NO. BS-122/XI/14

Design Change For Transmission Oil Filter TC-56010

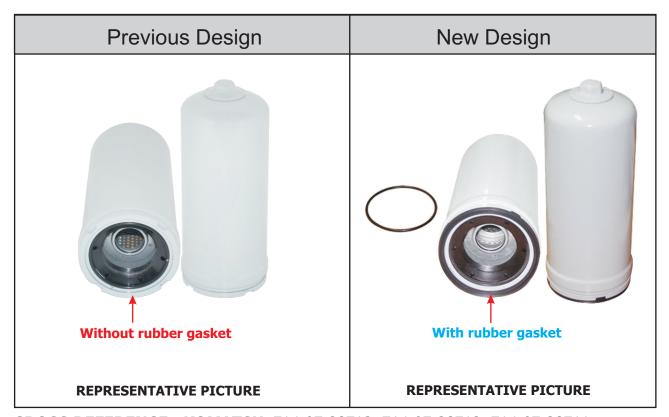
Please be informed, that we have changed the design of seat assy profile from without rubber gasket to with rubber gasket.
